Amendment No. 0004  
23 May 2003

SUBJECT: Amendment No. 0004 to Specifications and Drawings for Construction of  
Rearing Ponds and Hatchery Complex, Fort Peck Fish Hatchery, Fort  
Peck, MT.

Solicitation No. DACW45 03 B 0010.

**SHEET M8.03 AMENDMENT #0004**  
**GENERAL REVISIONS 5-23-03**

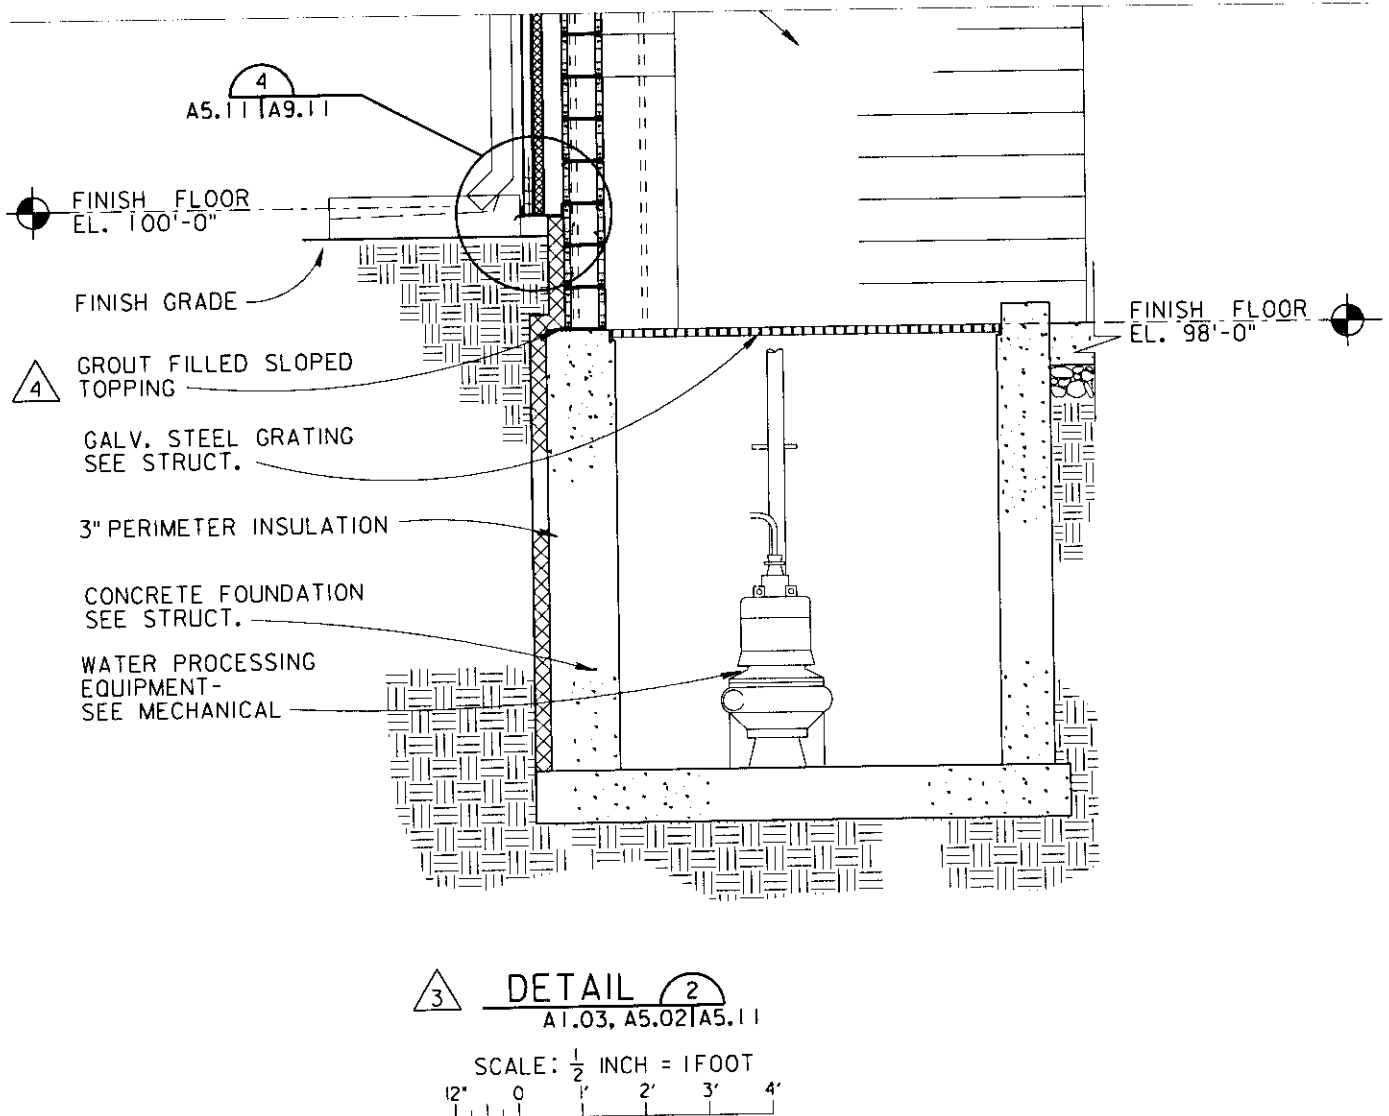
M8.08 Process Piping  
 A5.11 Detail 2  
 A5.20 Detail 4  
 A5.20 Detail 6  
 S1.03 Foundation Plan Area 'C'  
 S1.05 Foundation Plan Area 'E'

## SHEET S1.05 AMENDMENT #0004 GENERAL REVISIONS 5-23-03

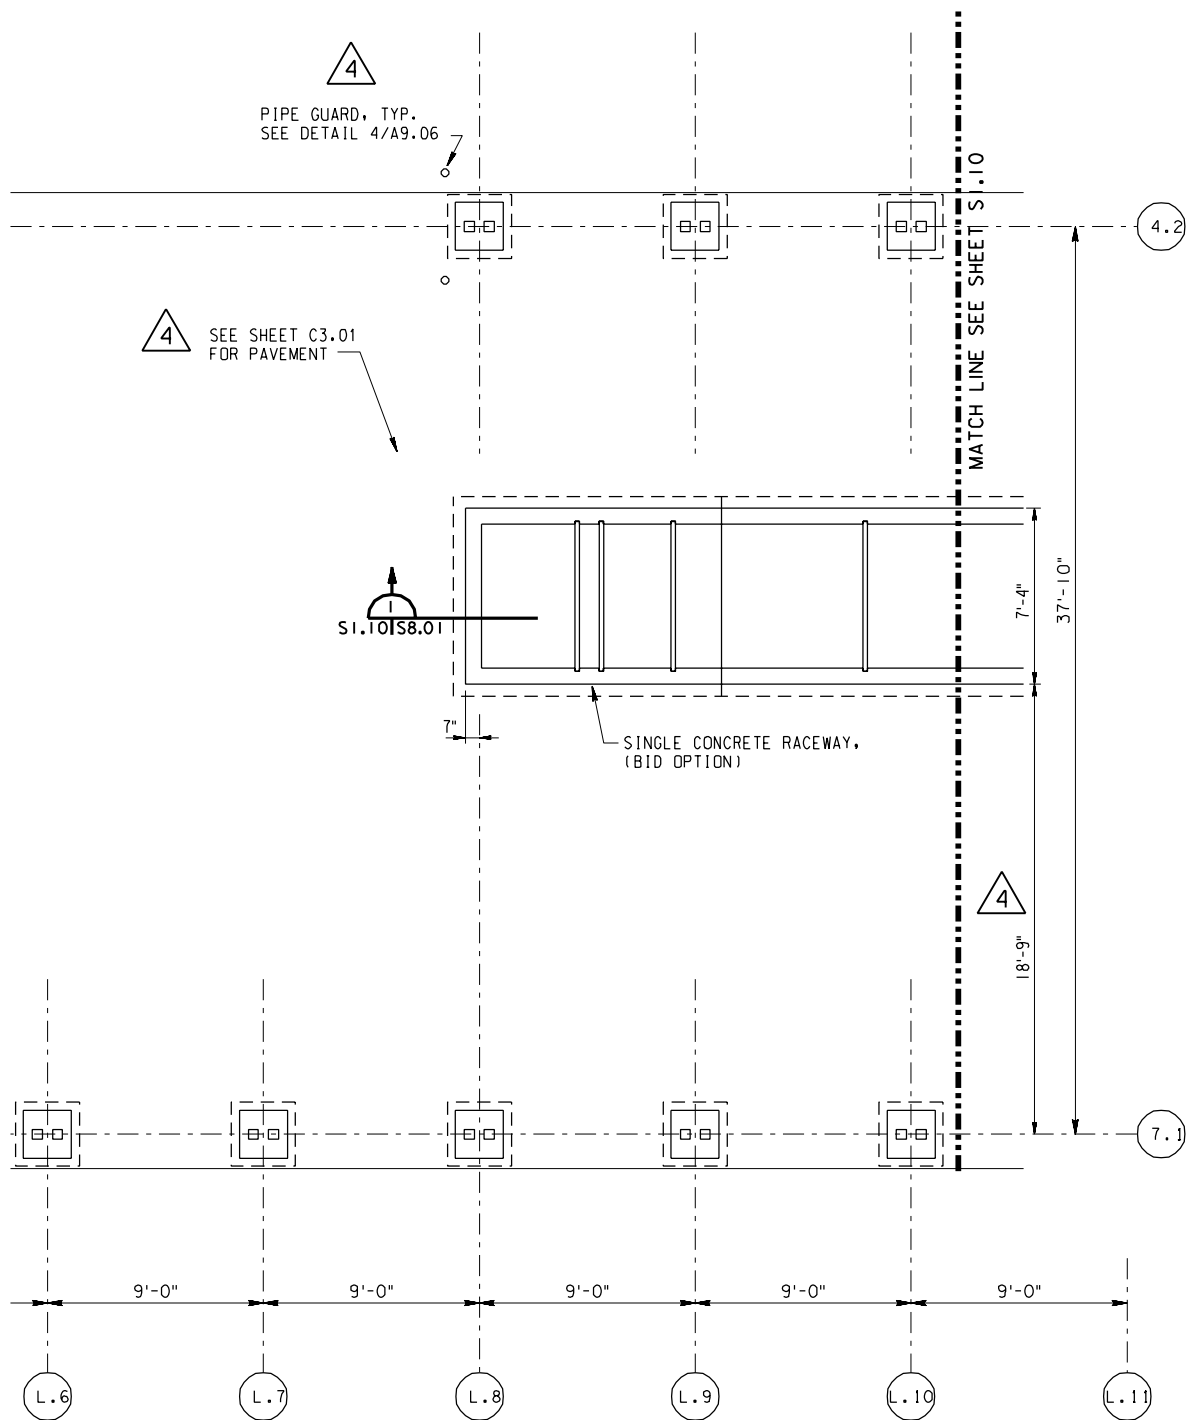
(6) Sheet S1.05 Note 2: delete "Tops of columns pedestals in Area E are Elevation 100'-0" unless shown otherwise," and substitute "Tops of columns pedestals in Area E are as shown on sheet S4.09 unless shown otherwise on this sheet."

**SHEET S1.09 AMENDMENT #0004**  
**GENERAL REVISIONS 5-23-03**

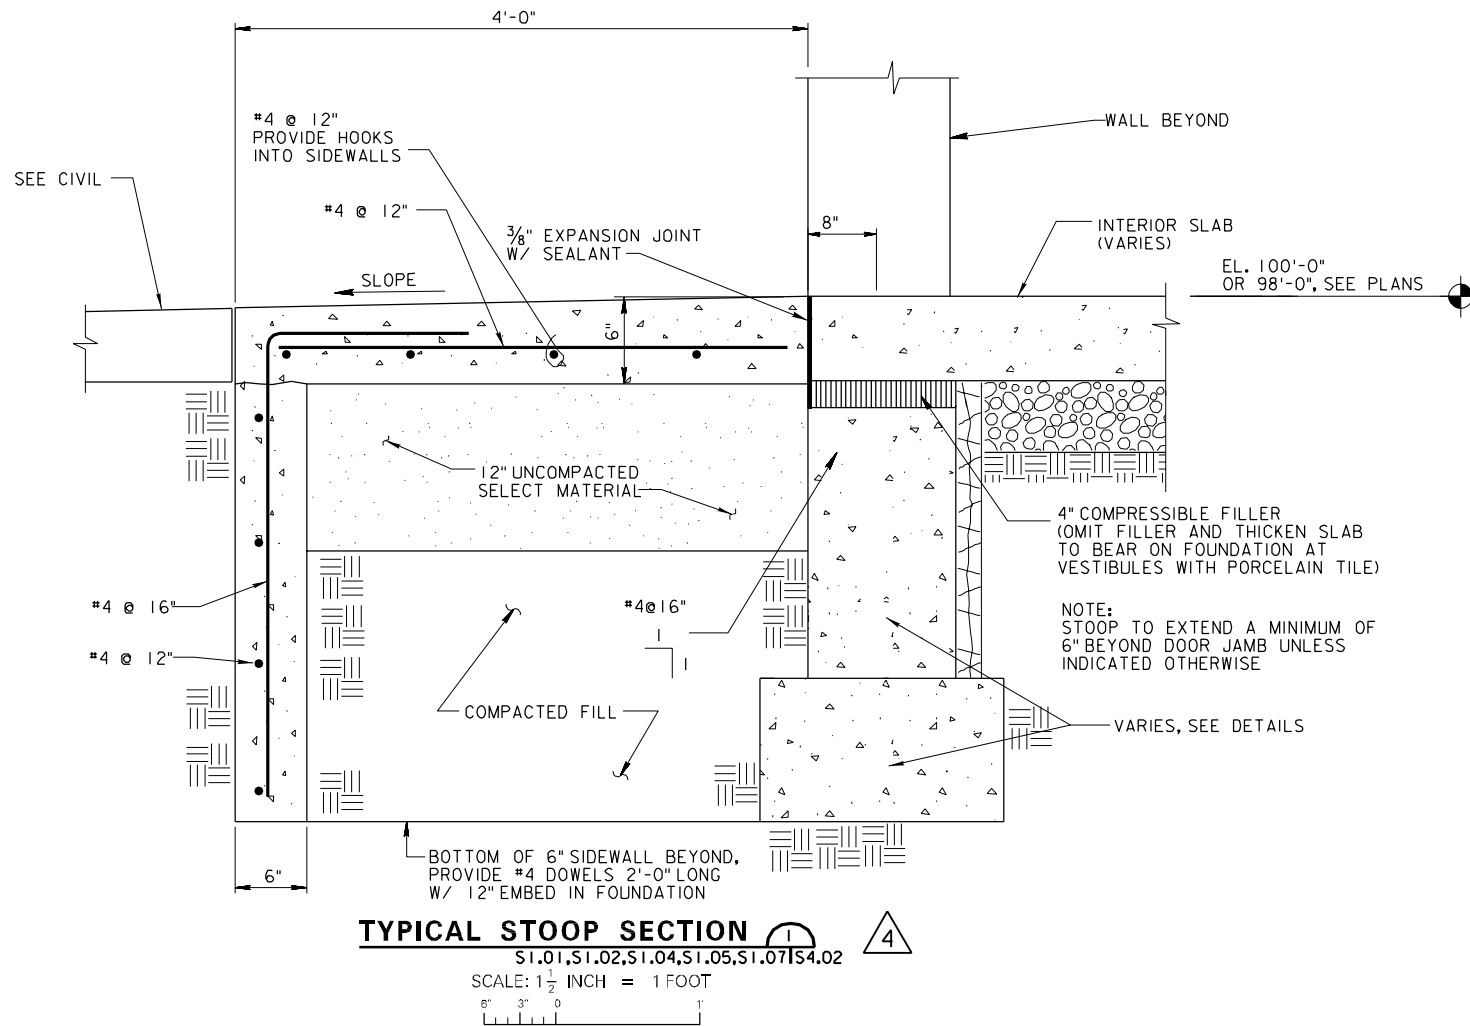
S1.09 Foundation Plan Area 'K'  
S4.02 Section 1  
S4.02 Section 8  
S4.02 Section 12  
S4.03 Section 15  
S4.03 Section 18  
S4.04 Section 22  
S4.04 Section 23  
S4.07 Section 1  
S4.08 Section 27  
S8.02 Raceway Fish Screen Detail  
S8.02 Raceway Adjustable Flow Baffle Detail  
S8.03 Section 1

**SHEET S4.09 AMENDMENT #0004**  
**NEW DRAWING ADDED 5-23-03**

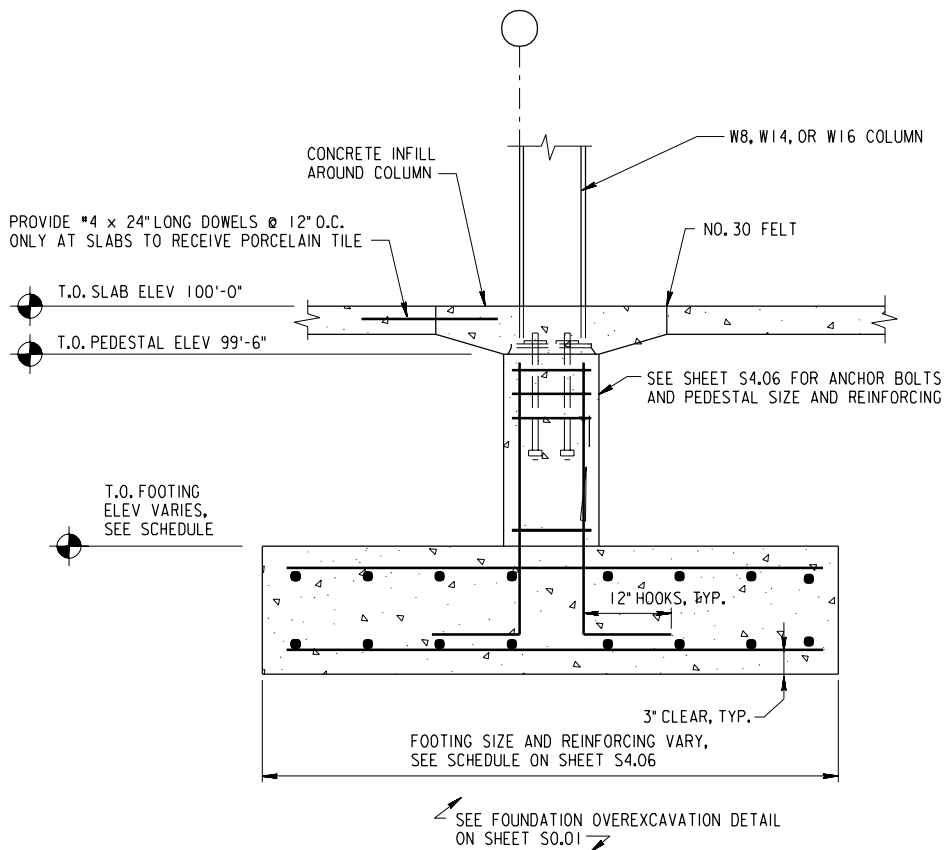
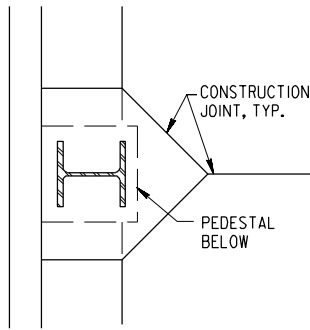
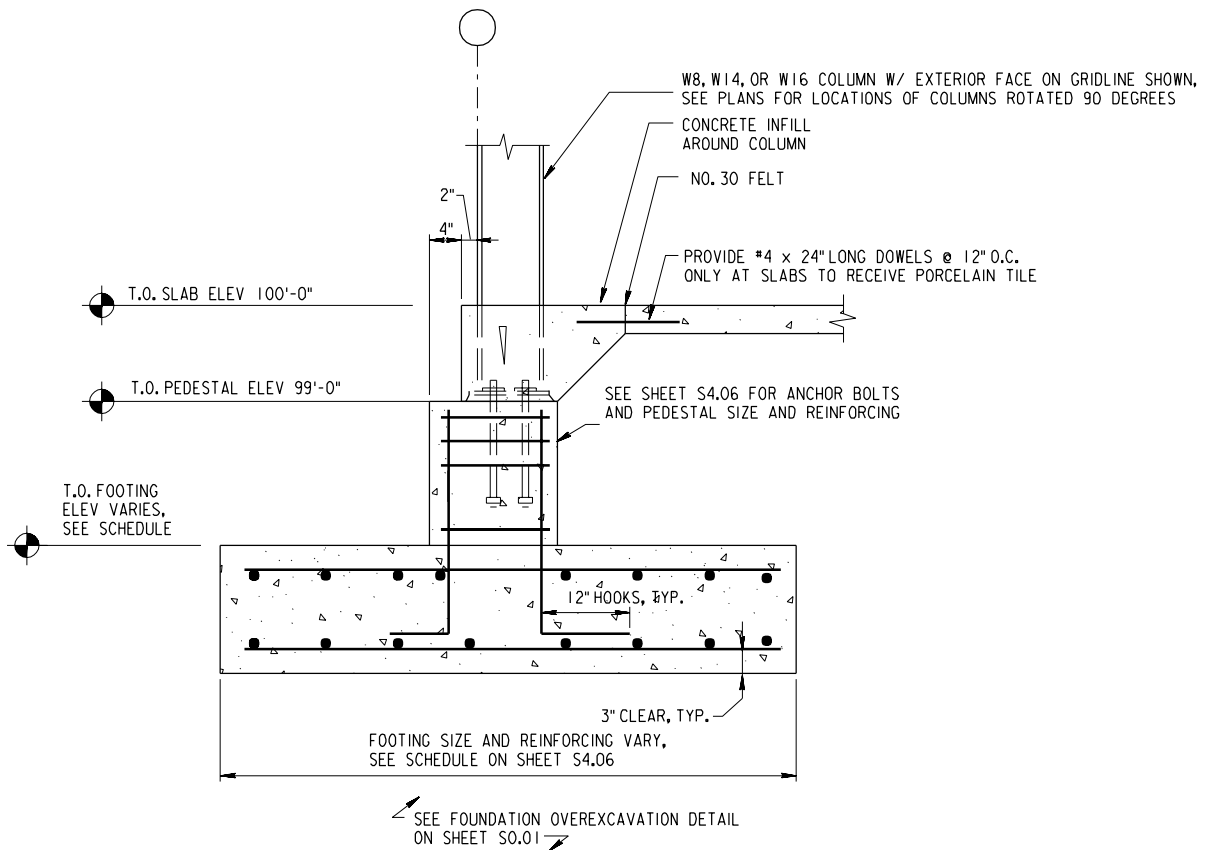
(4) Sheets S1.04, S1.05, S1.06 & S1.07, on Foundation Plans, revise control joint (CJ) layout adjacent to column pedestals in accordance with details on new drawing sheet S4.09 attached.

Sheet S4.09 on attached 8.5x11 pages, section "COLUMN FOOTINGS AND PEDESTAL SECTION AT INTERIOR COLUMNS NOT ON RAISED PEDESTALS" and "COLUMN FOOTINGS AND PEDESTAL SECTION AT EXTERIOR COLUMNS NOT ON RAISED PEDESTALS."
